McDONALD OIL SUBDIVISION

APPLICATION NUMBER 10 DATE August 4, 2005

REQUEST Subdivision

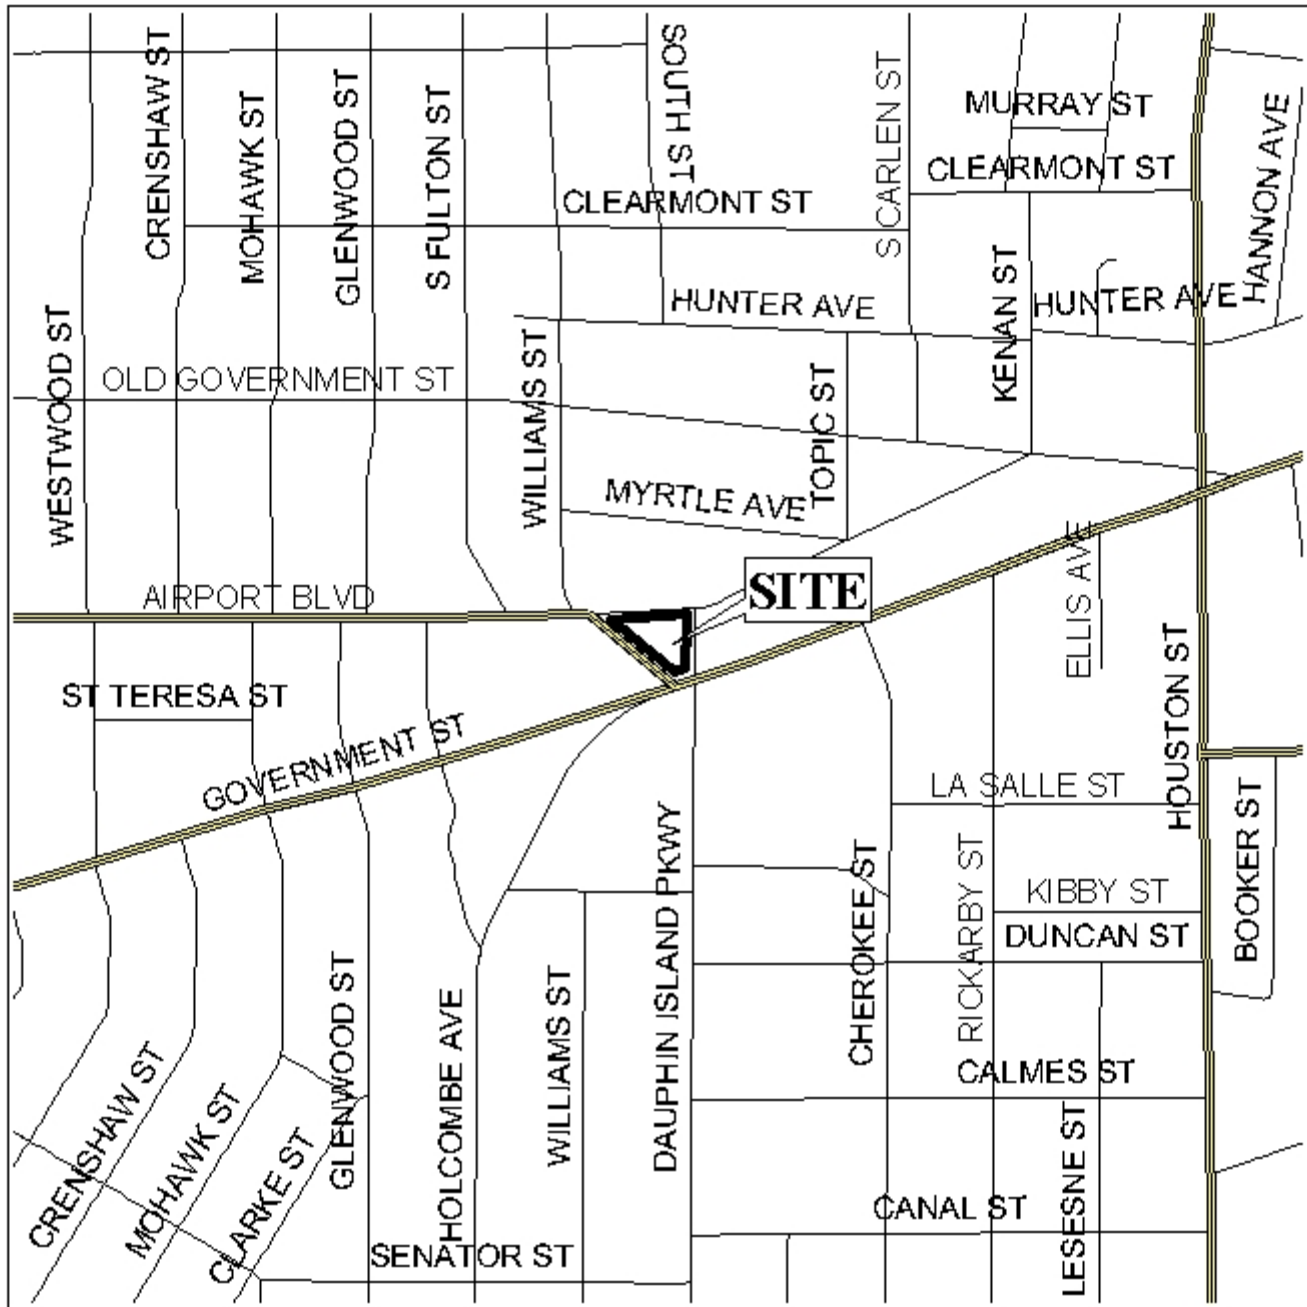
Given these facts, dedication of additional right-of-way would not be appropriate. However, as all four streets bounding the site are major streets or function as major street connectors, access management is paramount. Therefore, access to Government Street should be denied, and access to Dauphin Island Parkway, Airport Boulevard and Williams Street should be limited to one curb cut each, with the size, location and design to be approved by Traffic Engineering.

On a standard corner lot, the minimum building setback requirements may be reduced from 25-feet to 20-feet on the side yard. However, this proposed location is triangular in shape, having frontage of approximately 180-feet by 270-feet by 280-feet on each of the three sides. This creates a limited amount of building site coverage available for the site. Therefore, determining frontage will allow for the reduction of the minimum side yard setbacks to 20-feet.

With the site being a corner lot, the dedication of a 25' radius at Government Street should be required.

The plat meets the minimum requirements of the Subdivision Regulations and is recommended for Tentative Approval subject to the following conditions: 1) the placement of a note on the final plat stating that access to Government Street should be denied, and access to Dauphin Island Parkway, Airport Boulevard and Williams Street should be limited to one curb cut each, with the size, location and design to be approved by Traffic Engineering; and 2) the dedication of a 25' radius at Government Street.
